FL MCO GRNCH THREE (RNAV) STAR

4-14-2022 PRB Results: Returned for Rework

REQUESTED BY: AJV-A PBR RESULTS: RETURN FOR REWORK SEE ATTACHED FILE: 03-17-2022 PRB RESULTS ORLANDO INTL, ORLANDO, FLORIDA (MCO) - GRNCH THREE (RNAV) STAR

## Procedure Review Board (PRB) Assignments March 17, 2022

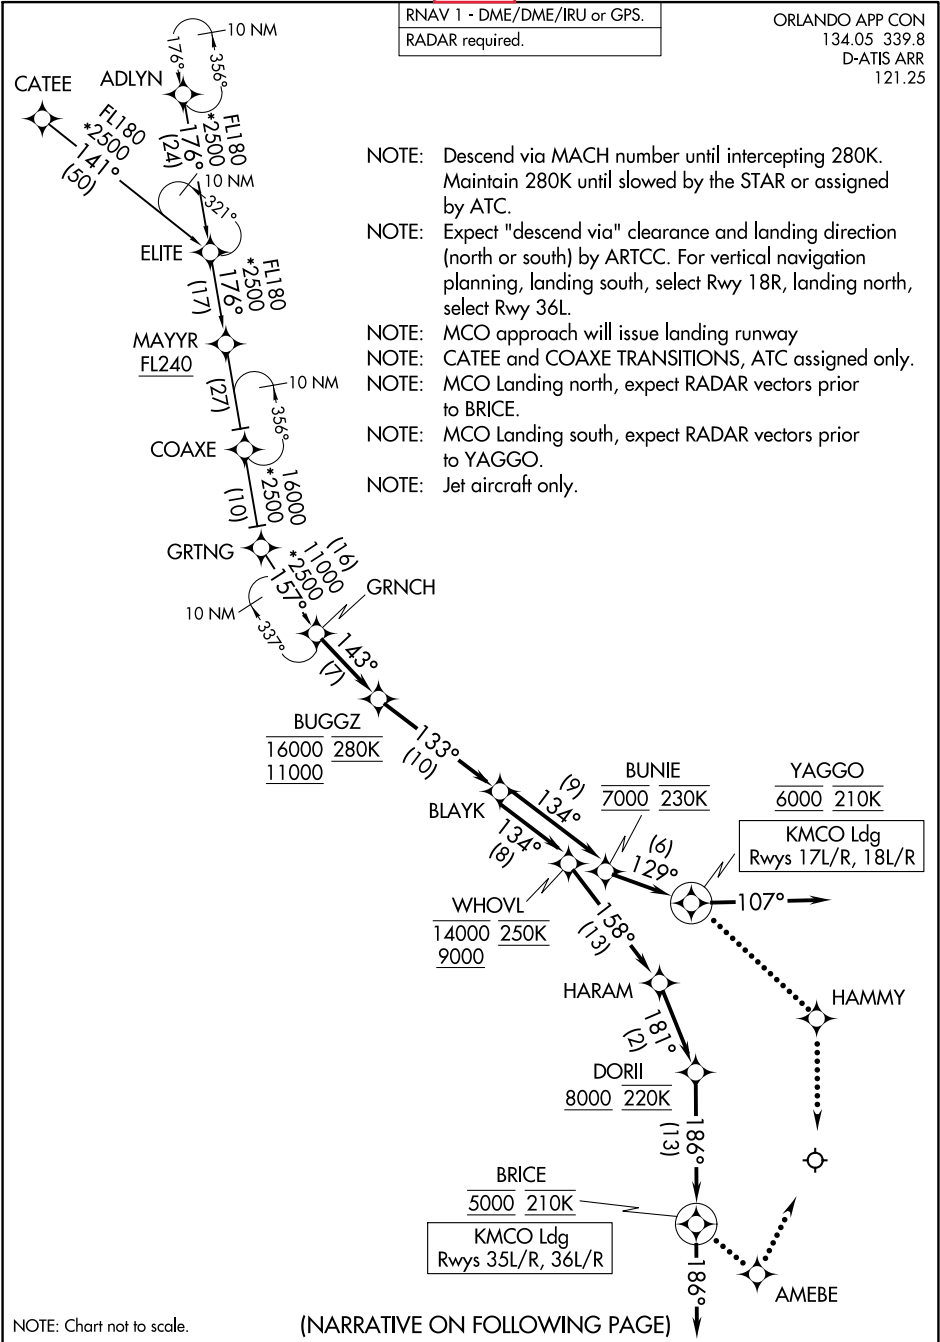
6. IAW 8260-19, para 8-5-2g1: 8260-2: JAMIZ: Fix use doesn't show STAR but the procedure is

based on it.

- a. Add to FIX USE: STAR, GRNCH (RNAV), KMCO, ORLANDO, FL(US)
- b. Add to REQUIRED CHARTING: STAR

[AJV-A requirement](#)

Subject: Descent Gradient Approval Request: GRNCH RNAV STAR, KMCO

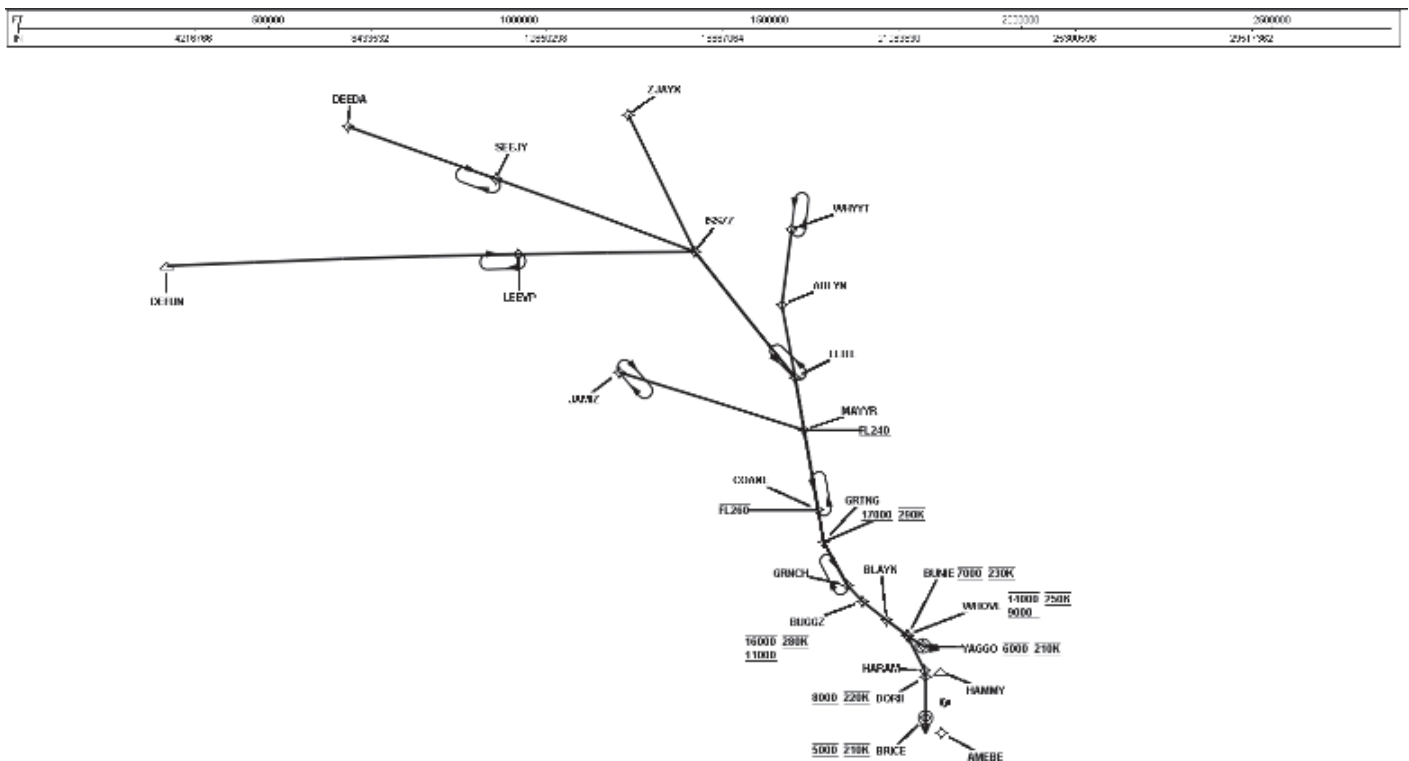
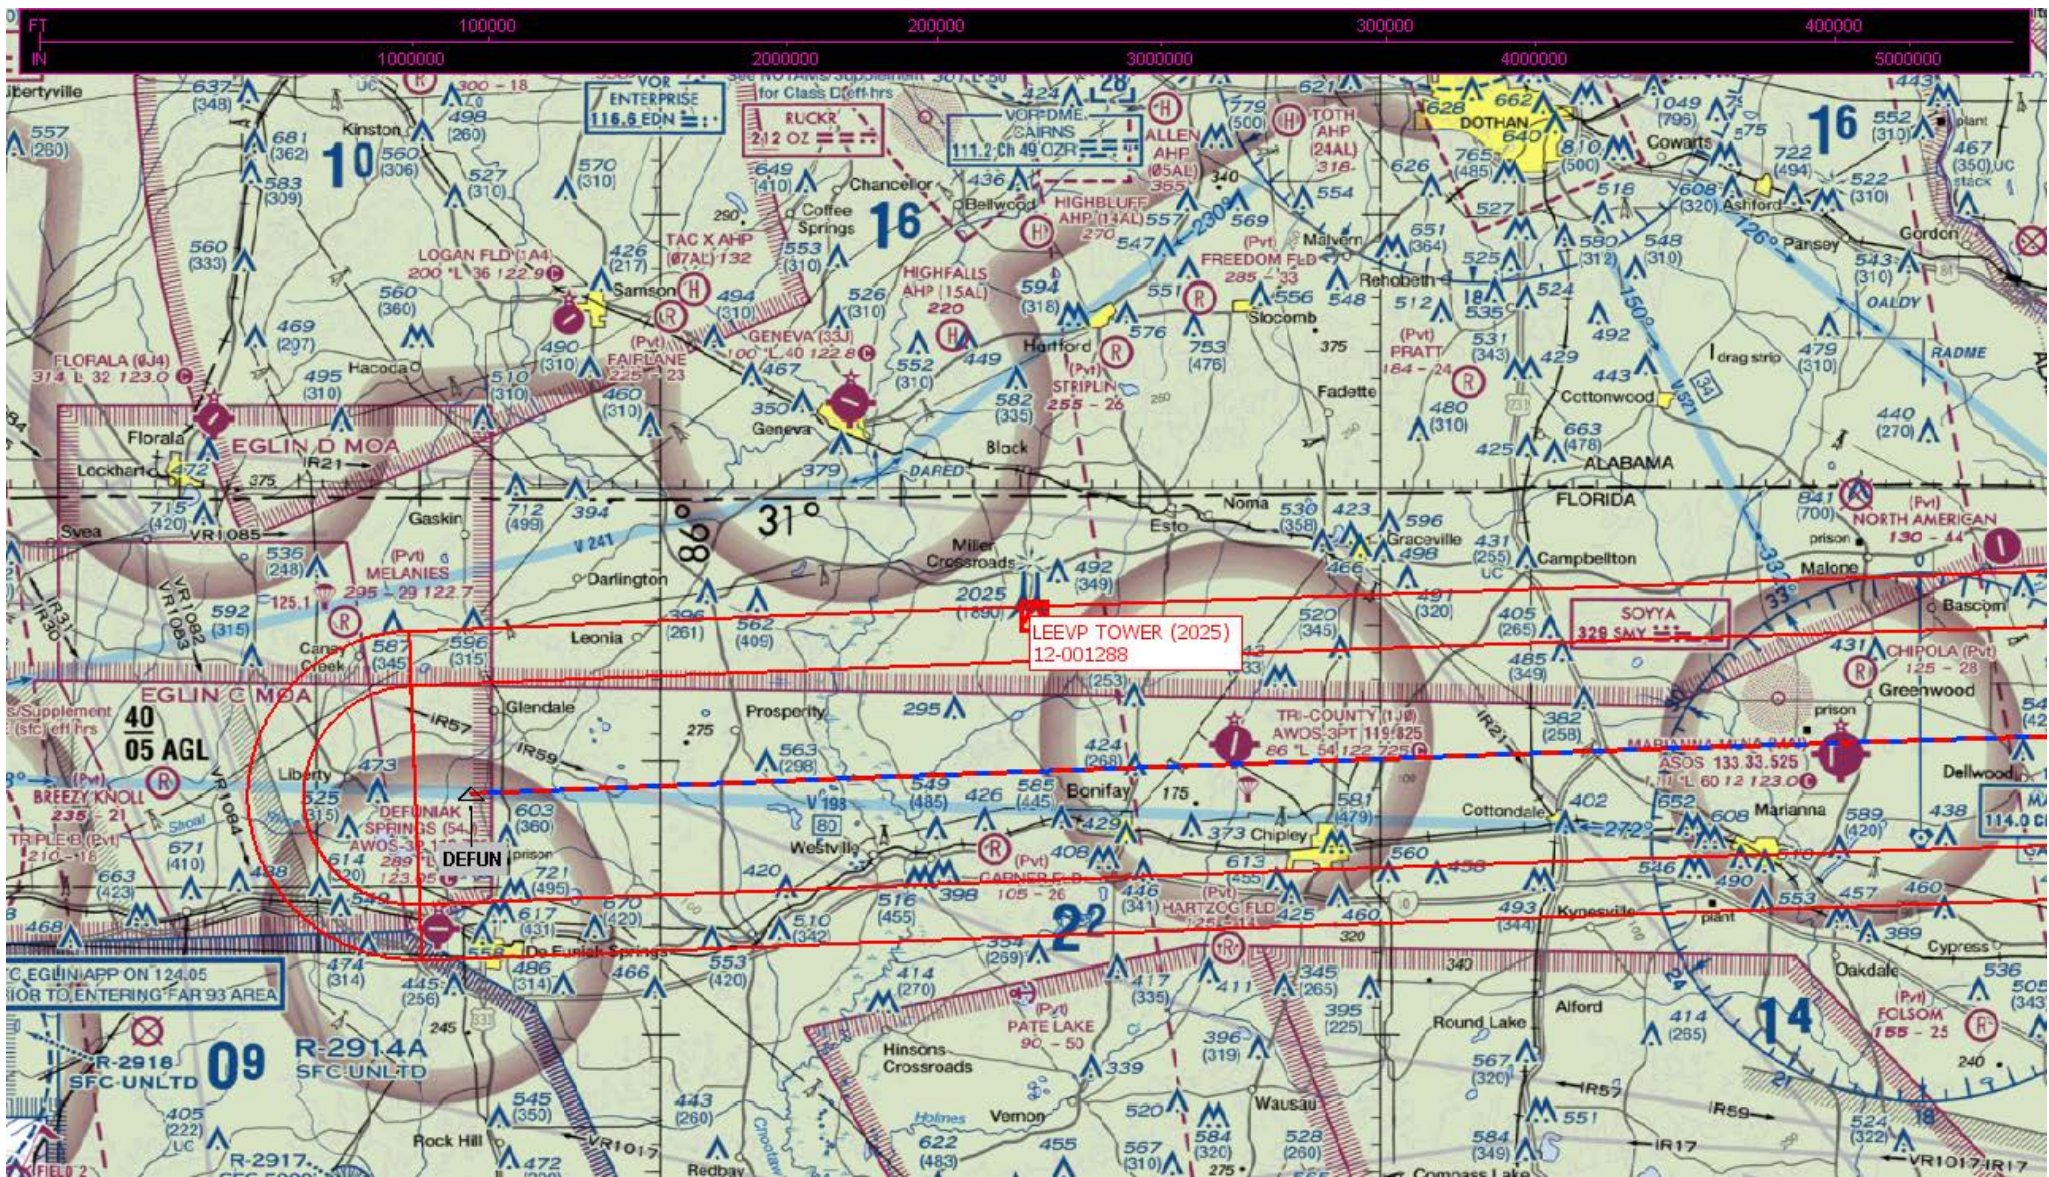
A computed descent gradient value from COAXE to GRTNG of 859.73 ft./NM resulted over a distance of 10.46 NM from the descent gradient being calculated from descending from the restriction of AOB FL260 at COAXE to cross GRTNG AOA 17000 290 KIAS. Calculating a descent gradient from COAZE to BUGGZ (Cross between 11000 and 16000) resulted in a descent gradient of 321ft per NM.

Consideration was given to removing and or changing the restrictions at COAXE, however, to prevent aircraft from entering adjacent airspace above the GRNCH STAR and to reduce ATC workload due to required coordination, (point outs) it was decided that the restrictions are necessary.
